IFB #2023-39

Northview Midrise Underground Water Storage Tank

ADDENDUM NO. #1

FIRE TANK DETAILS

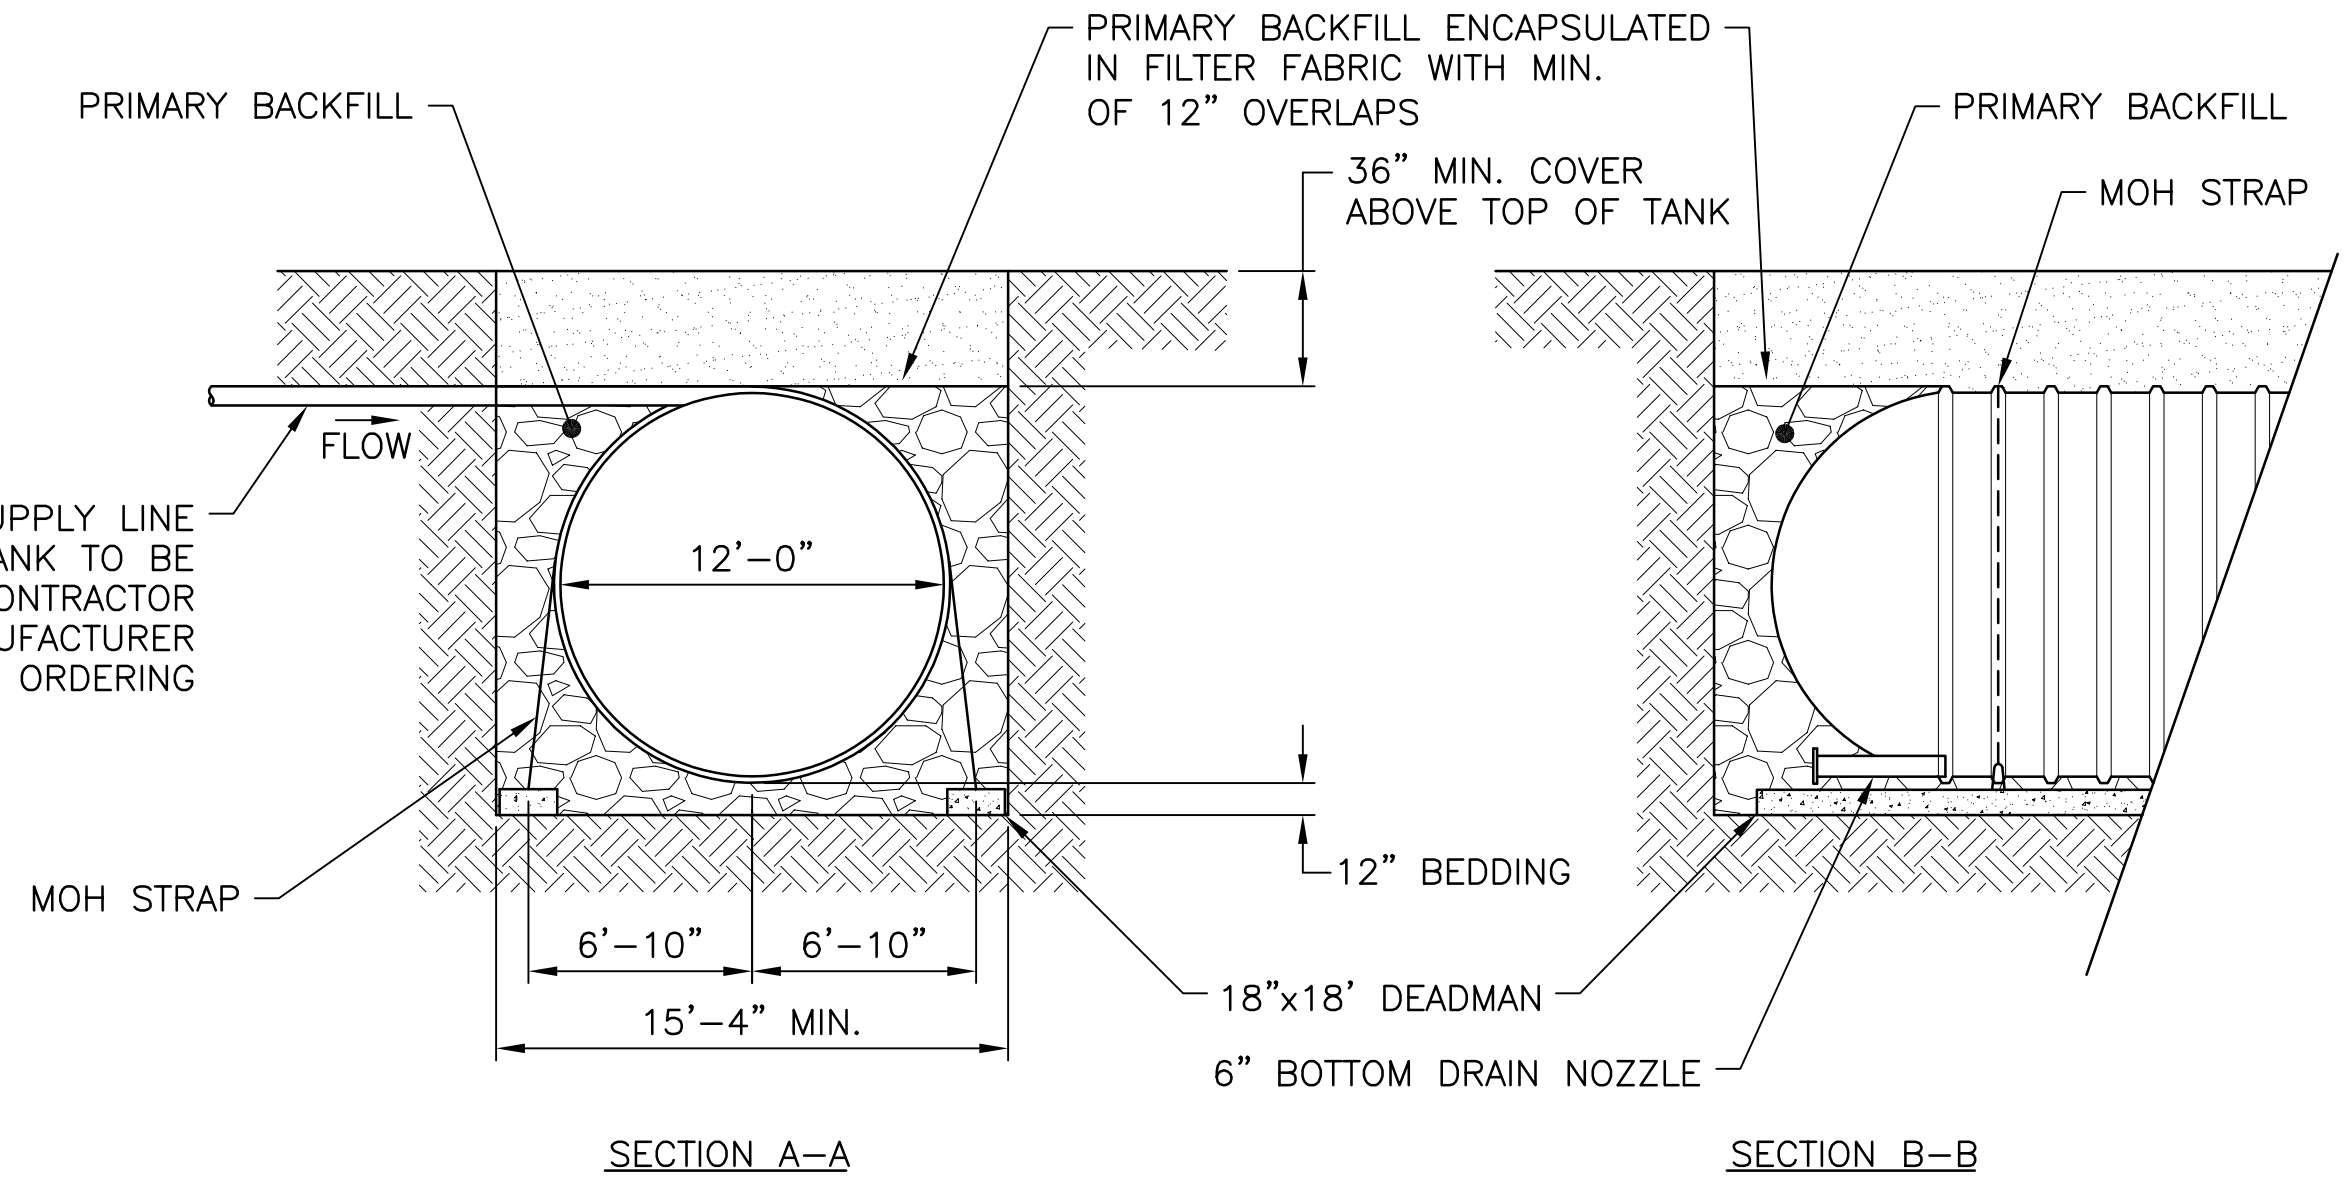
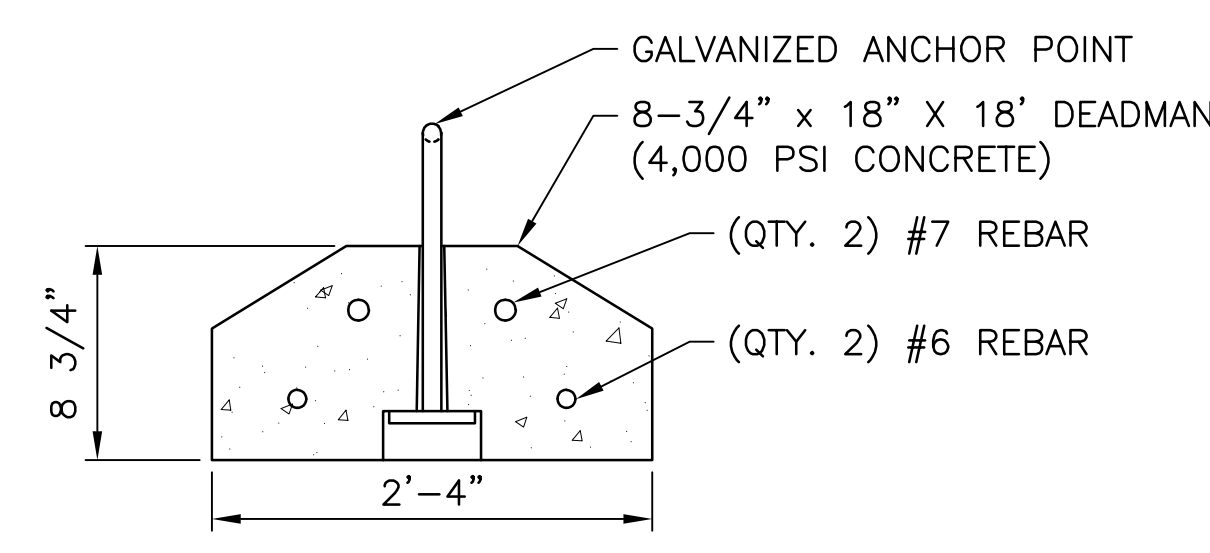
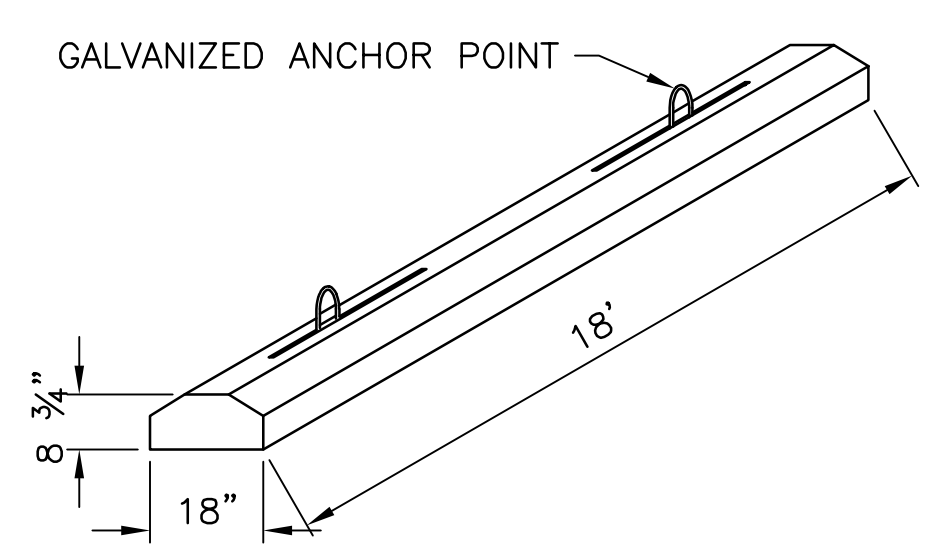
Item 1: Q: There are some drawings for a 50k f/g u/f water tank in the Civil and Fire Protection drawings. However, I did not see a spec section for this tank. Do you happen to know if there is one or might be coming out in an addendum?

A: Bureau of Fire, City of Pittsburgh required the originally proposed 20,000-gallon tank to be replaced with the 50,000-gallon tank included in the IFB and required a change in the way the firefighters would access the water in the tank. The 20,000-gallon tank will be deleted from the scope of IFB #2022-37. The selected contractor for IFB #2023-39 will need to coordinate with the selected four prime contractors for IFB #2022-37 to execute the work related to the new 50,000-gallon tank and associated vault, piping, and valving

Item 3: The meter vault and water lines to the meter vault and storage tank have been relocated. Dimensional information for the meter vault has also been include along with minor revisions as noted as "Rev. 17". Attached are the revised sheets, C300, C400, C500, C552, C553, C554. C600. Please see Attachment A – Specifications Table of Contents and Section 33 16 00 and Attachment B – Civil Drawings for the aforementioned information.

A: Attached is the Specification Section 33 16 00 Storage Tanks, for the Water Tank as well as the Specification Table of Contents to include this section.
